DRAINAGE INFORMATION SHEET

Re: Site Plan submittal for building permit approval for Office Warehouse for Alan Regis, 1635 Second St. N.W., M.R.G.C.D. Map No. 37, Tract 279-A, (Zone Map J-14-Z), Architect's Stamp dated 7/14/99. [J-14/D134]

The above referenced plan requires modification to the Site Plan prior to Building Permit release as detailed on the following attachment:

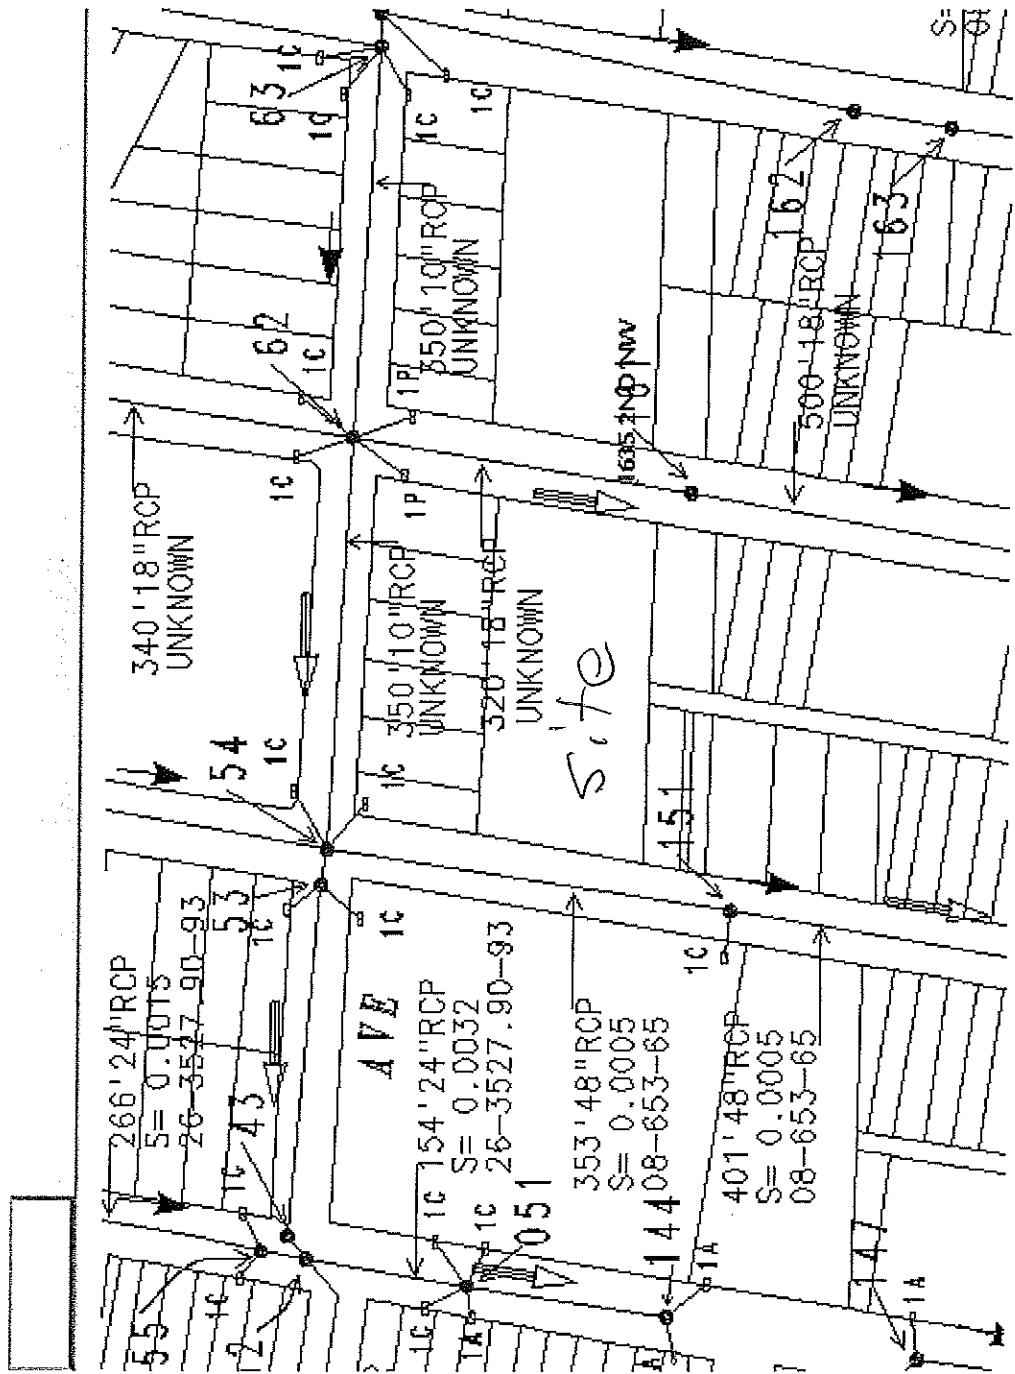
- The engineer's certification required by the Hydrology section needs to include certification that this site was constructed in accordance with the Traffic Circulation Layout (TCL) before C.O. is released. Place this note clearly on Site Plan.

- Only one SitePlan is needed per Permit submittal. Multiple copies of SitePlans will need to match exactly.
- New and existing elements noted on the Site Plan must be shown, labelled, and dimensioned correctly and accurately, this includes, curb & gutter, all drive aisles, drivepads, parking stalls(including H.C.[or refer to detail]), landscaping, and fencing.

- Show, label, and dimension existing and/or new street sidewalks. City sidewalk ordinance requires minim.6' street sidewalks along the frontage of all commercial sites being developed adjacent to major streets.

- Dimension stalls - can be labelled "typical" or call out in individual locations, if not typical.
- Label concrete curb(at locations shown), and type (or show detail labelled "typical" or reference COA. Std. Detail Dwg. No. 2415), at each individual location or, if used, call out double-line style linework (or equivalent), used to symbolize curbing, as "typical".

- Minim. 5' wide sidewalk, raised 6" above parking surface, needed at the front of parked vehicles along the front of building. Needed except where concrete apron at overhead doors is being constructed. __Remove wheel stops. __H.C.ramp must be constructed at H.C. parking as part of sidewalk, as shown. __Show ramps and slope of ramps using arrows or refer to detail.

- Gates must be 20 feet beyond the back of sidewalk to accommodate a vehicle stopping to open the gates, if they are to be locked during business hours, also to allow unimpeded pedestrian use of sidewalk. __Gates must be 25 feet minim. width(unobstructed). Dimension gate width. __20' distance from back of sidewalk needed at entrance for vehicle visibility and to allow safe vehicle circulation.

- Proposed use of overhead doors on commercial sites requires that plan reviewer looks for large wheelbase-30' (refuse/UPS) vehicle to be smallest to use doors. As linework shows on Site Plan(using traffic turning template), there is insufficient room for backing up to overhead doors. This site layout will not allow enough room for this condition without backing from or into street. This violates provisions in theDPM,Sect.23.6B.8b.2 & 23.7B.8. __Loading/unloading of trucks behind vehicle stalls is prohibited[cr]. Consult DPM for service vehicle use.

- Label - "Construct new drivepad per City of Albuq. Std. Detail Dwg. No. 2426.
- 25' radius curve needed on end island along refuse path as shown. __Minimum width of end islands-10'.

- Show and label property lines and right-of-way lines.
- Need to see that all existing obstacles in City right-of-way, in existing sidewalks, have been picked up.

- All Civil Sheets (Drainage Plan, Site Plan and Landscape Plan) must be together at front of permit plan set.
- Linework on DrainagePlan and LandscapePlan must matchSitePlan exactly. This office recommends that as much information as possible that is pertinent to it's requirements be placed on Site Plan and not Drainage Plan. Any changes required by Transportation shown on Drainage Plan cannot be marked up on Drainage Plan per Hydrology's preference, such as curbs, ramps, drivepads,dimensions, labels, etc.
